BAR 4-17-01

CERTIFICATE OF APPROPRIATENESS APPLICATION BAR 00-7-31
308 East Market Street

Ms. Vest reported on the application of Charles Kabbash for construction of a new porch at 308 East Market, which could be accessed from an upper floor apartment. The matter had been denied by the Board in July of 2000 due to concerns of the porch's location in relation to and proximity to Market Street; expense/size of the deck; and the quality of drawings submitted. Since then, she stated, the applicant had retained an architect for assistance with design and presentation issues. Staff, she said, had reviewed the resubmitted application and supported it, feeling that it now met the design guidelines, though the porch remained quite close to Market Street so that that BAR concern remained. Ms. Fenton invited additional comment from the applicant.

PLAN AT SECOND FLOOR
1/4" = 1'-0"

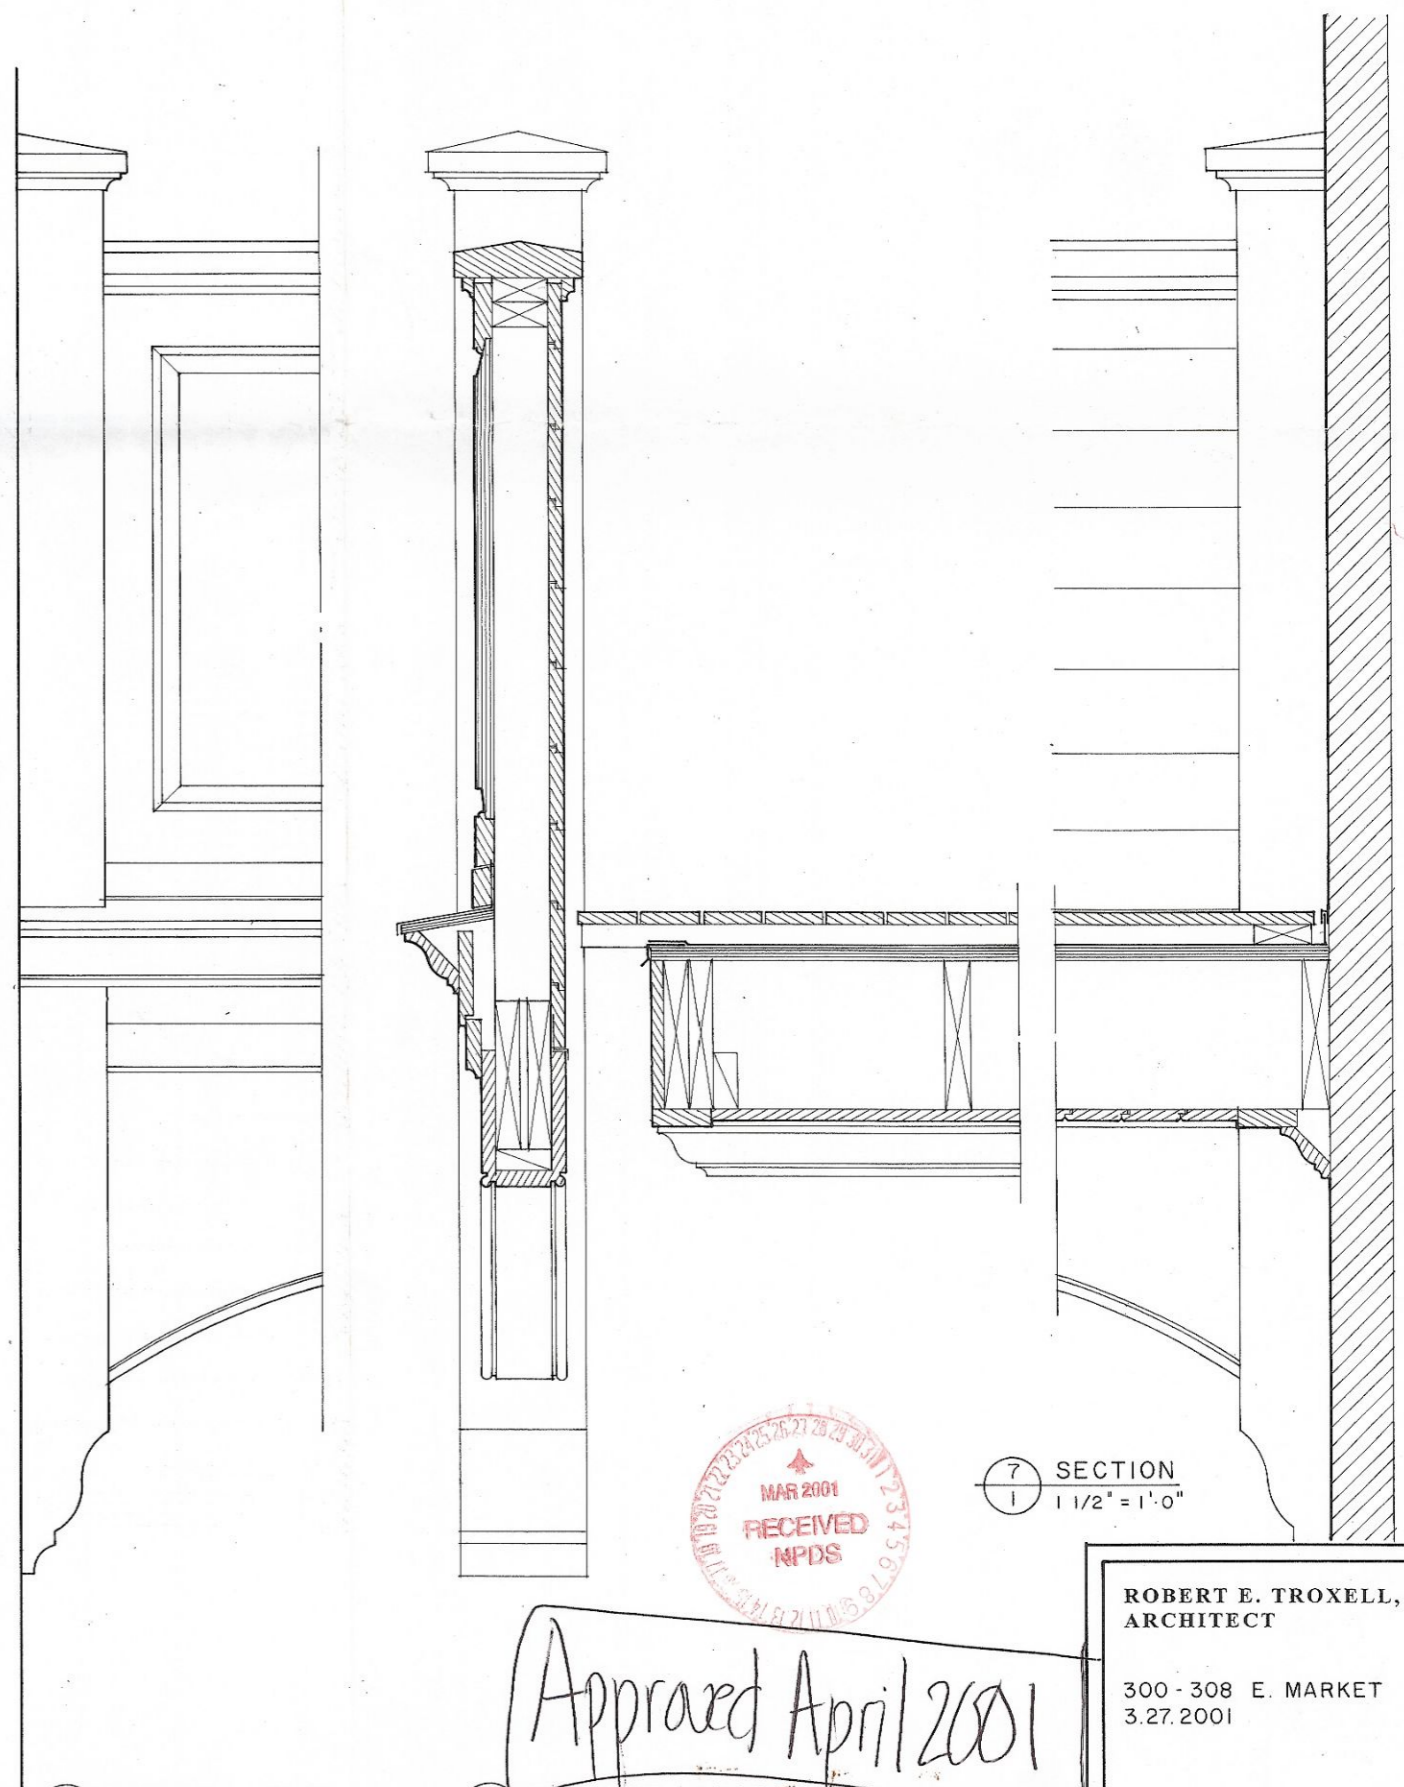
The architect stated that, for him, the porch's proximity to Market Street was of concern from the standpoint of privacy, both for the City and the residents of the building, which was why the open balustrade Mr. Kabbash wanted had been replaced with a solid panel. He thought that this, plus the height of the railing, cut off any sightline so that no

Mr. Schwartz commented favorably on the ceiling design under the deck, saying it created a very clean surface and that it was a very positive detail even though it was an added expense and unnecessary for structural integrity.

Mr. Kabbash added that the deck had also been changed to waterproof materials, and was to be built "like you would build a house."

The architect stated that their concern had been for anything that could be seen from the street to be finished, painted millwork and that it would age well, which was why they went to waterproof material for the deck.

Ms. Fenton commended the applicant and architect on what they had accomplished. Mr. Schwartz remarked that he had been very skeptical about putting anything there at all from what he had seen the previous time. He expressed delight with the proposal presently before them, saying that the porch fitted comfortably between the two buildings in a very delicate way. He called it a strong proposal.

Ms. Fenton invited a motion. Mr. Coiner remarked that he had seen this same concept, in places outside of Charlottesville, that looked really good. He moved for approval as submitted, seconded by Mr. Atkins. The motion carried unanimously. The applicant thanked the Board.
